Aurora Reference
DA-2062-32
Case No. 2022-6020-00
FDR RSN: 1819828

RE: The Aurora Highlands Parkway Phase 2 (38th Pkwy to 26th Ave) (DA-2062-32) ISP Response Letter

THE AURORA HIGHLANDS PARKWAY INFRASTRUTURE FILING NO. 1

A RESUBDIVISION OF A PORTION OF TRACT E, THE AURORA HIGHLANDS **Addressed** SUBDIVISION FILING NO. 1
SITUATED IN SECTION 29, TOWNSHIP 3 SOUTH, RANGE 65 WEST OF THE SIXTH PRINCIPAL MERIDIAN,
CITY OF AURORA, COUNTY OF ADAMS, STATE OF COLORADO
SHEET 6 OF 7

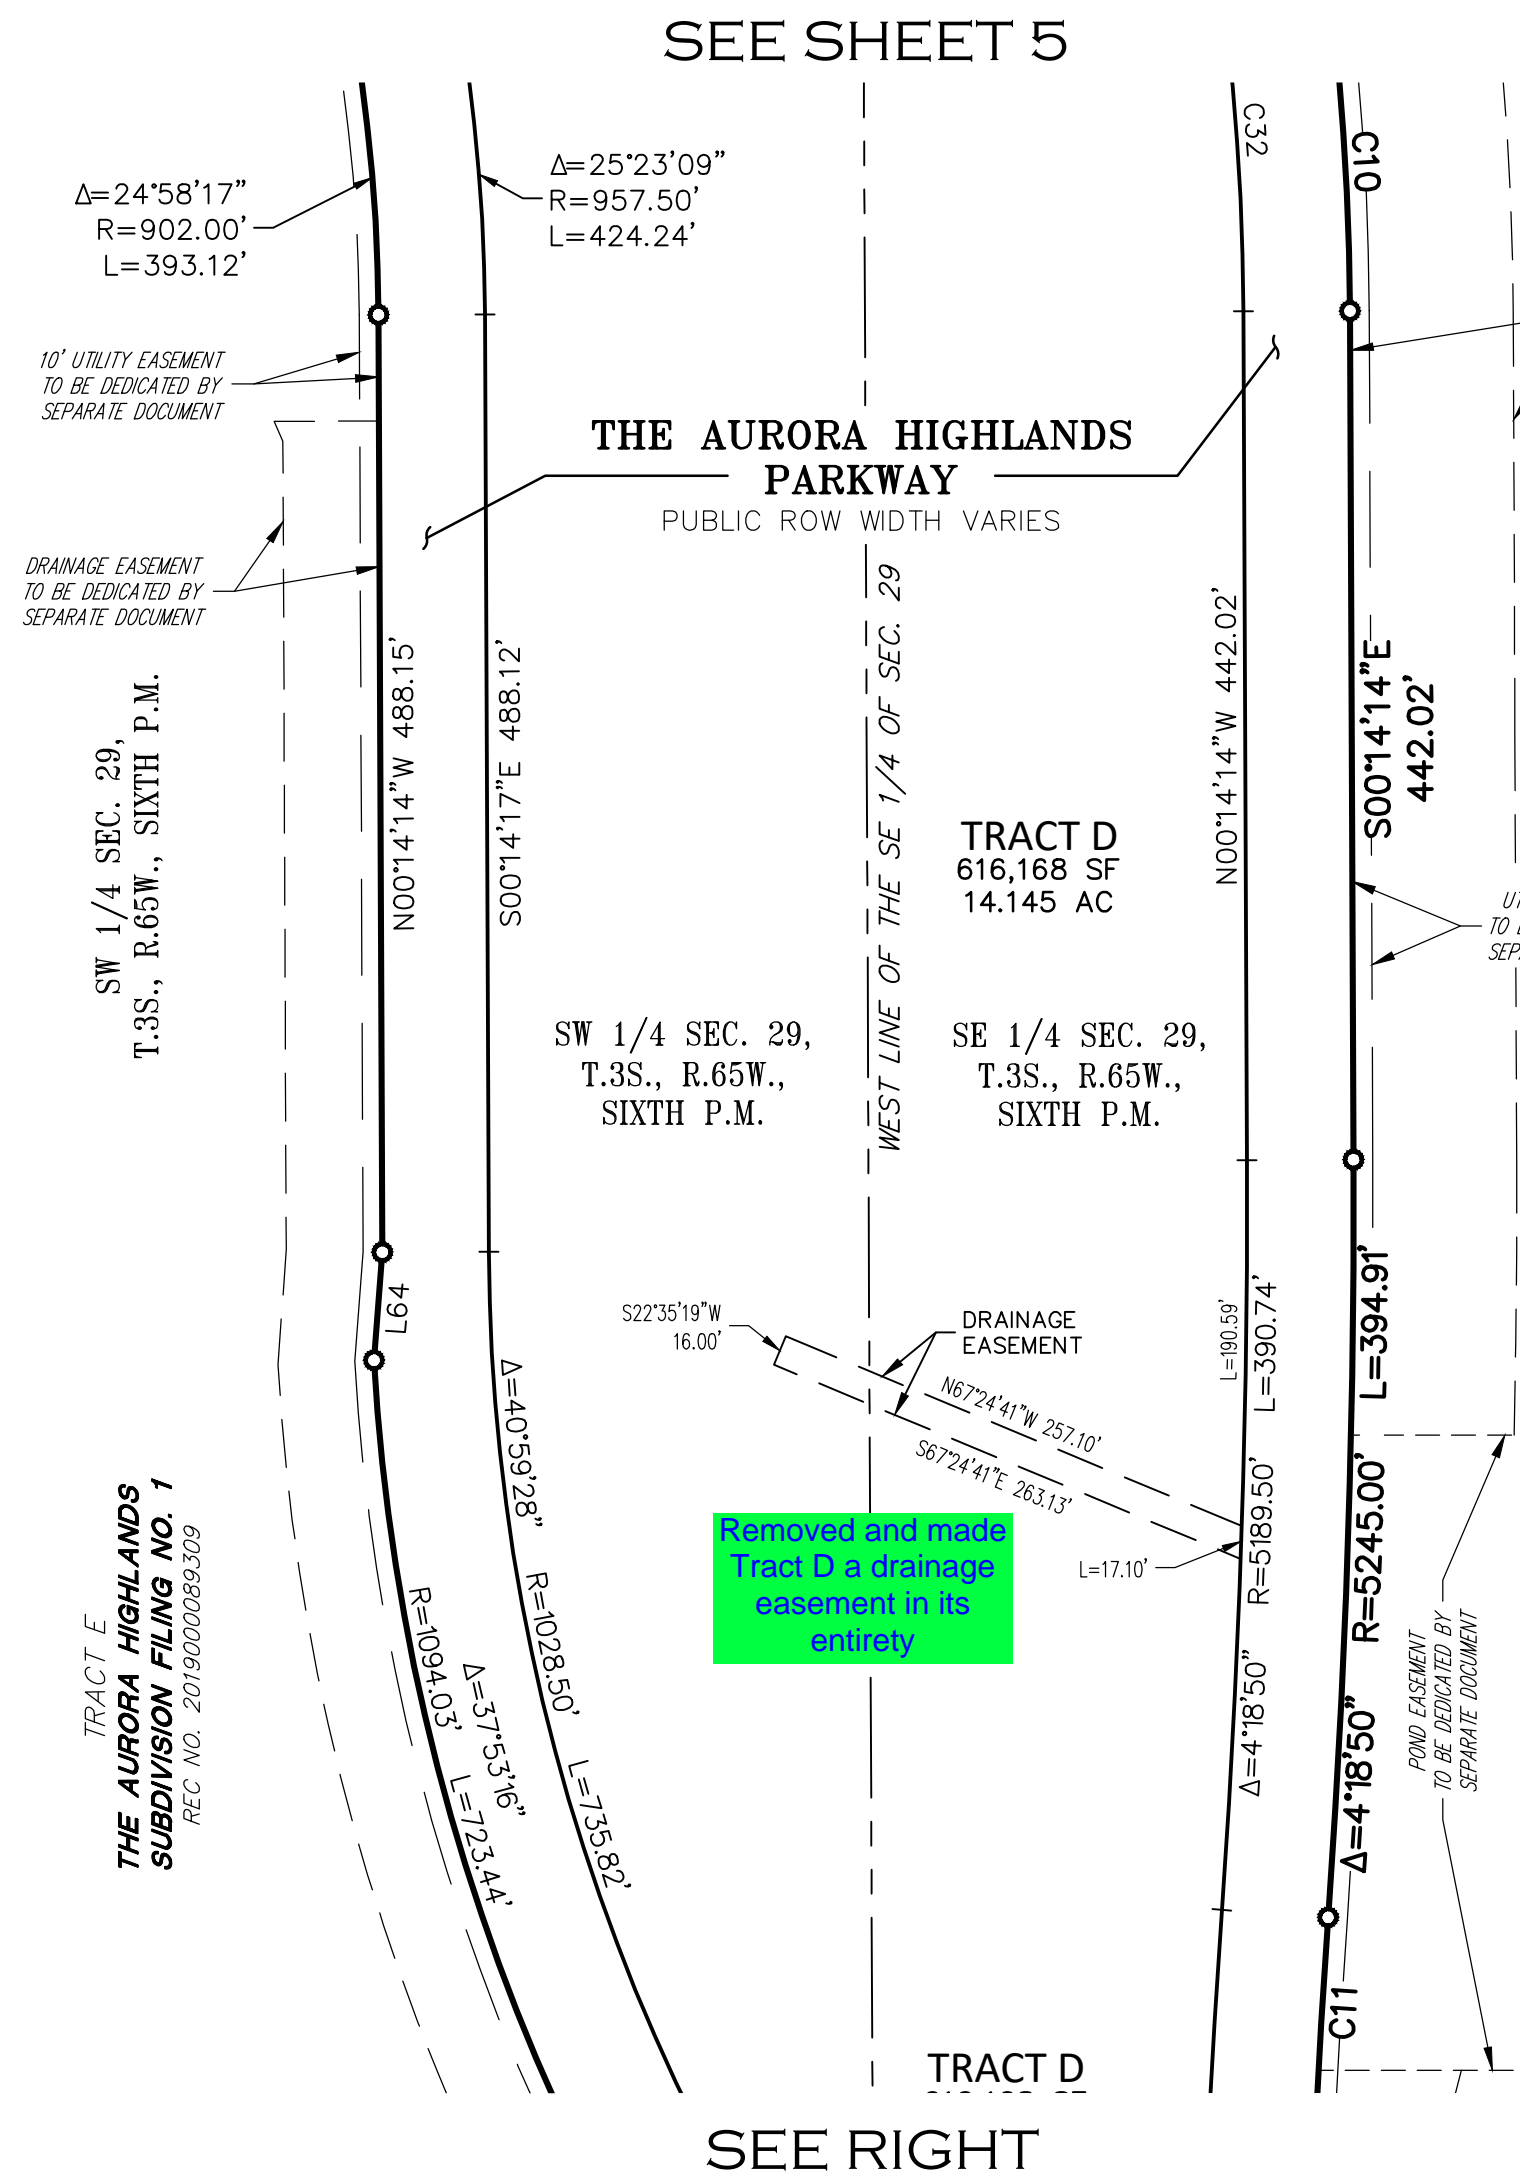
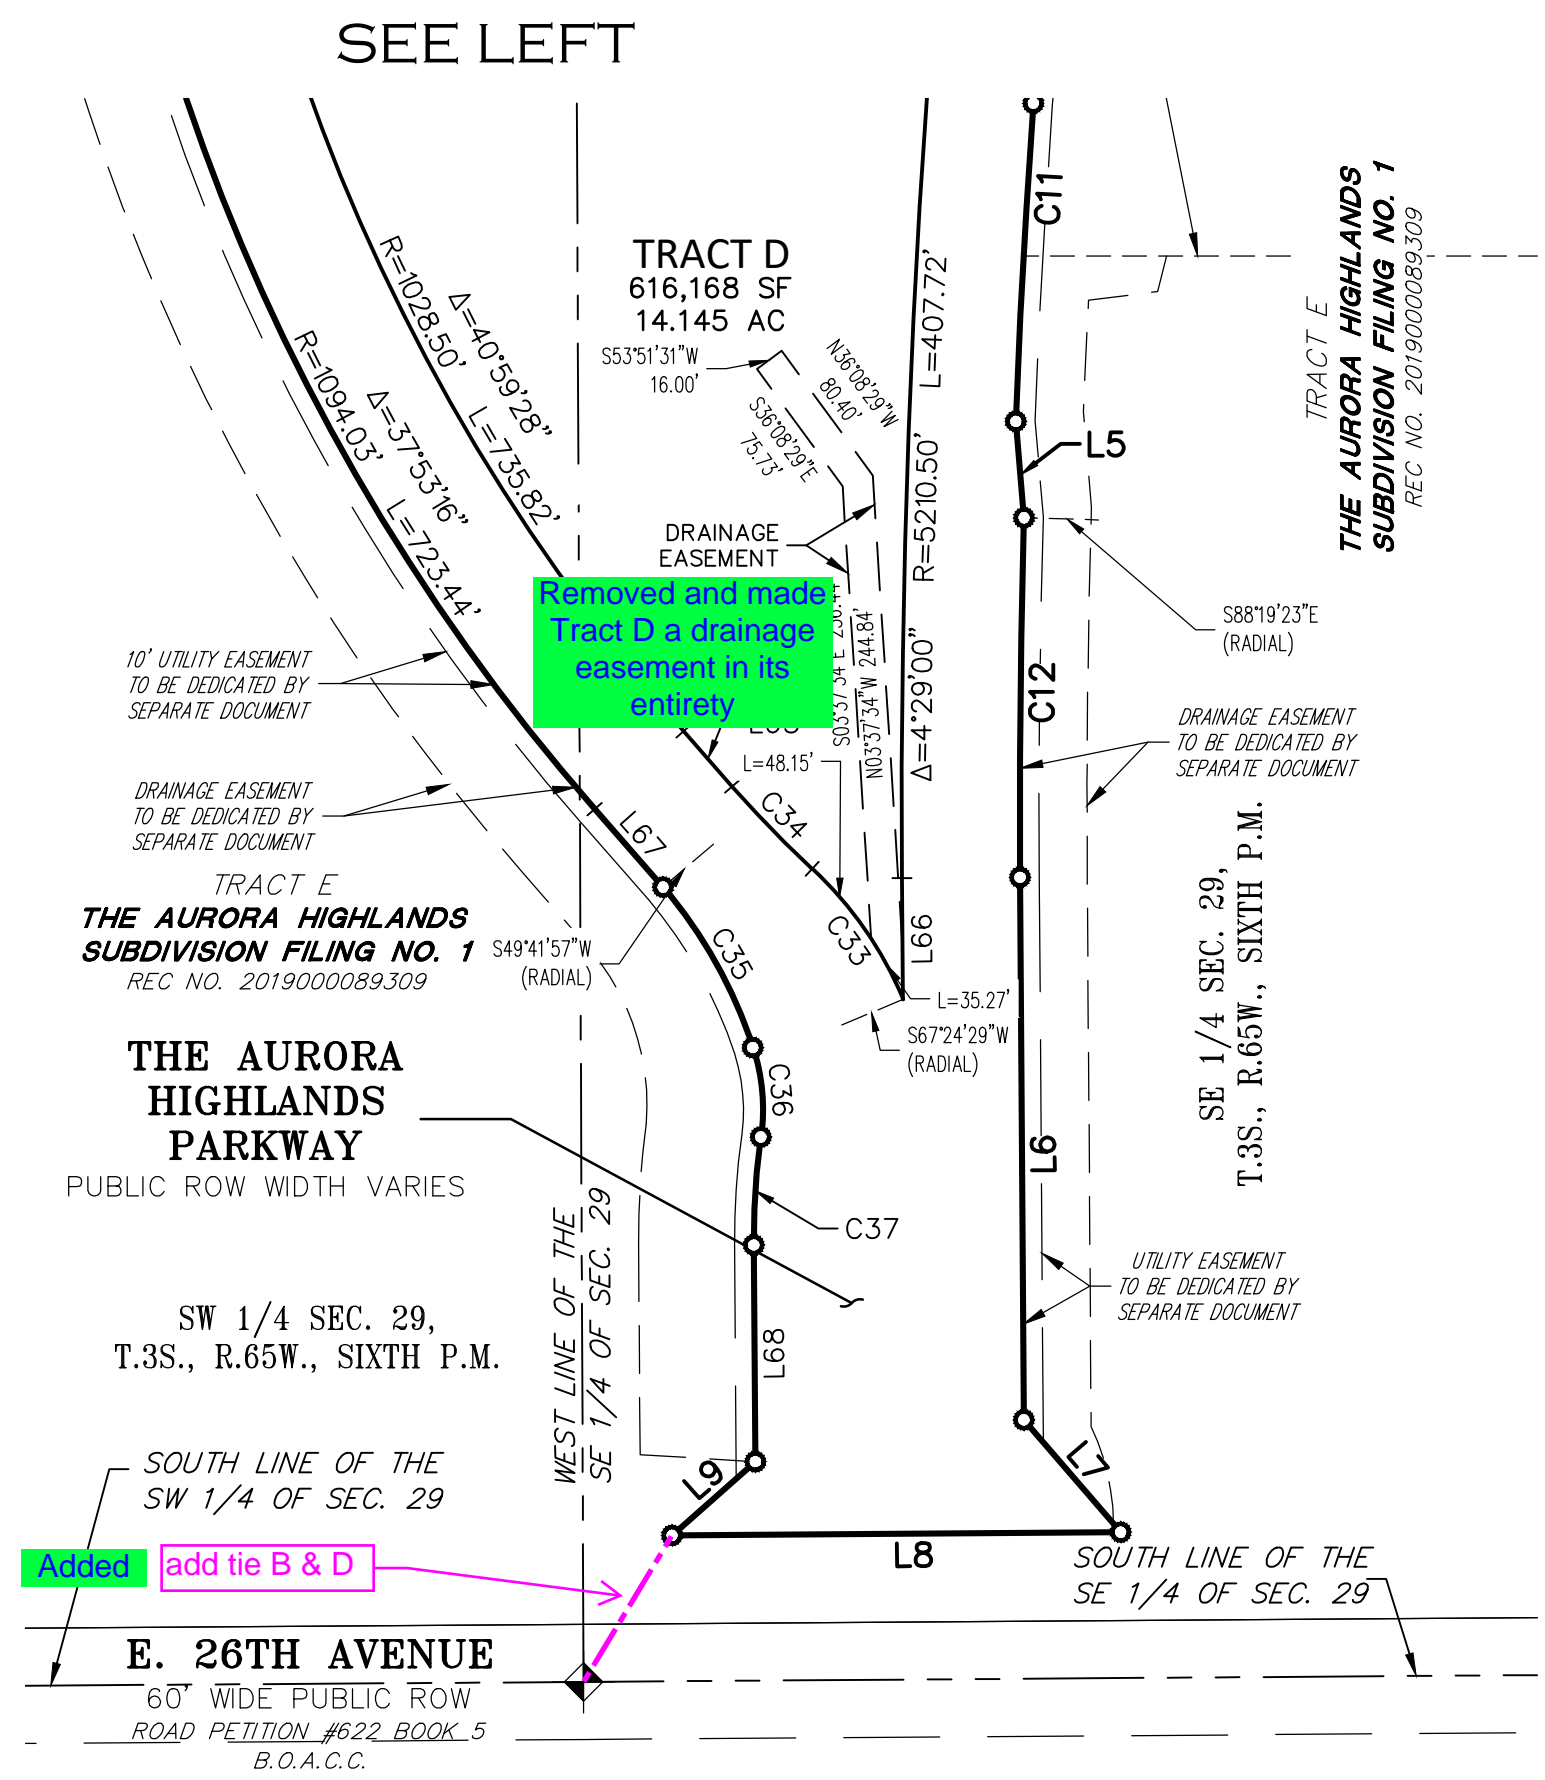
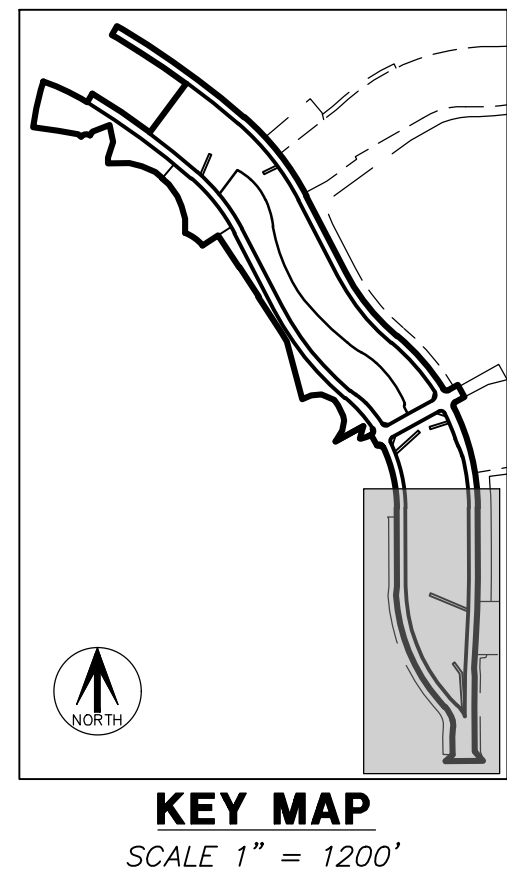
Maurice Brooks	60		Sheet 6	Add tie B & D	A	Addressed.	Survey	A	20-Mar-25	BM	
Maurice Brooks	61		Sheet 6	Legend question mark about the Notes	A	Addressed.	Survey	A	20-Mar-25	BM

A RESUBDIVISION OF A PORTION OF TRACT E, THE AURORA HIGHLANDS **Addressed** SUBDIVISION FILING NO. 1
SITUATED IN SECTION 29, TOWNSHIP 3 SOUTH, RANGE 65 WEST OF THE SIXTH PRINCIPAL MERIDIAN,
CITY OF AURORA, COUNTY OF ADAMS, STATE OF COLORADO
SHEET 7 OF 7

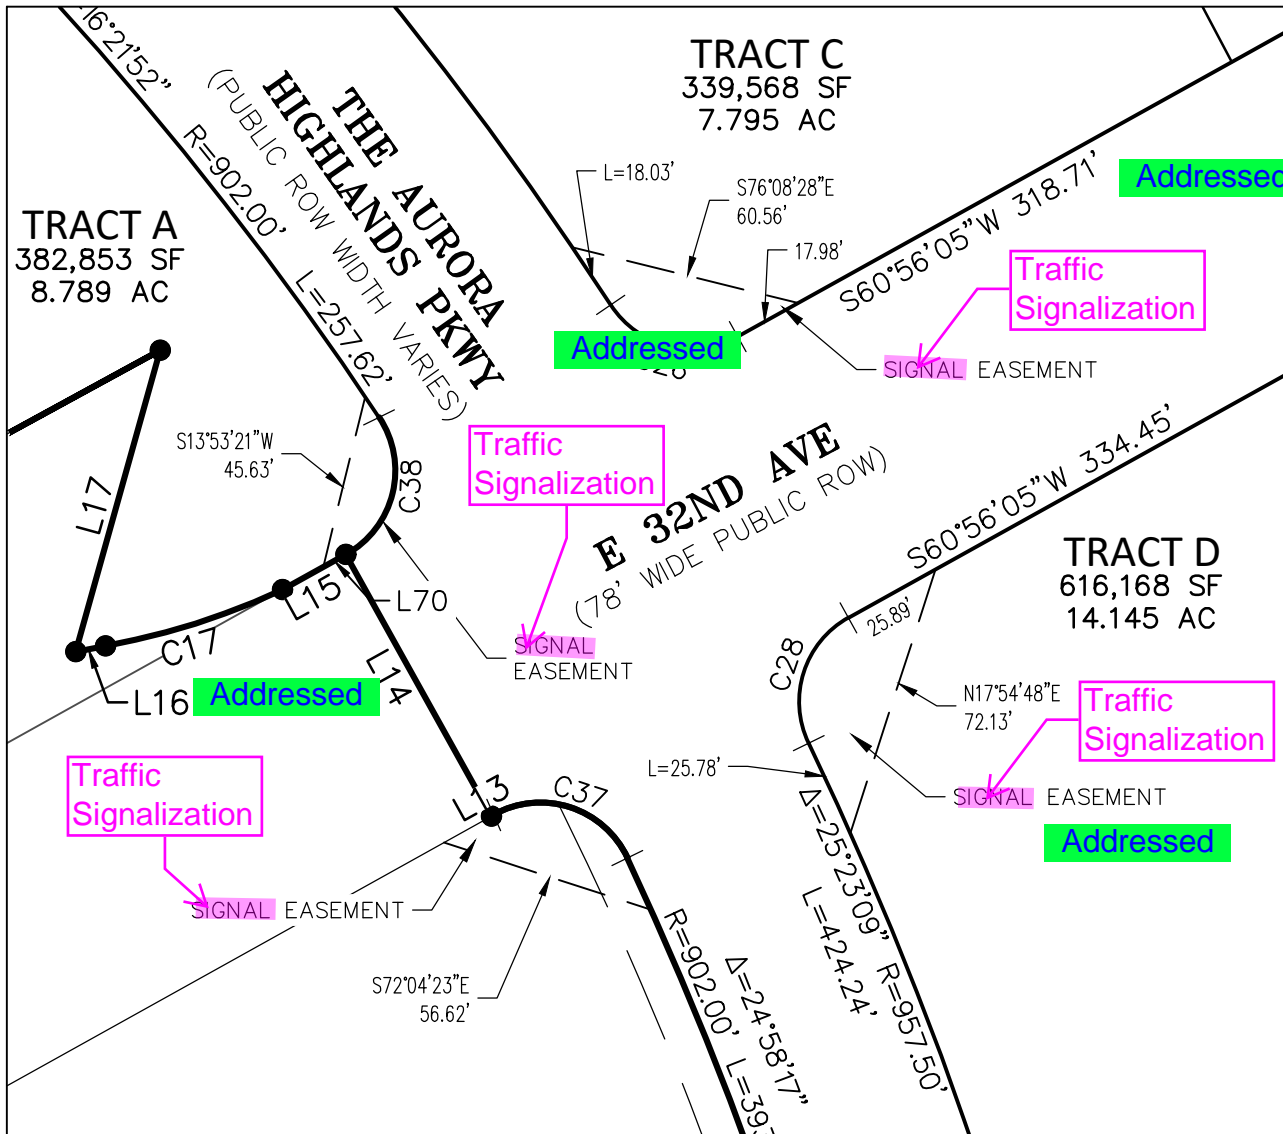
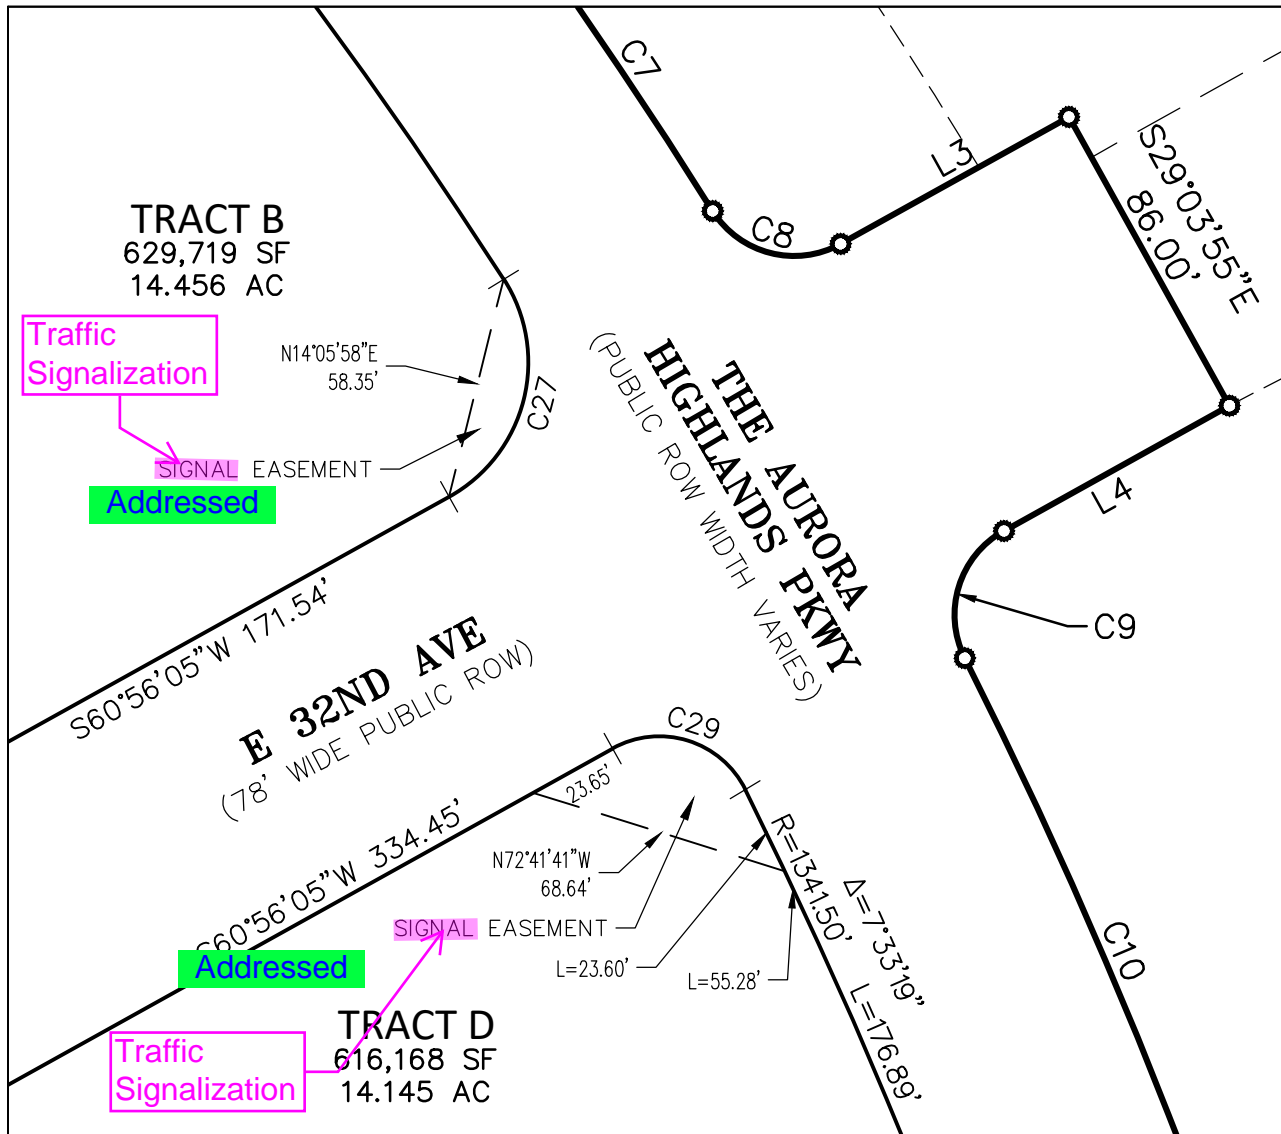
? Revised
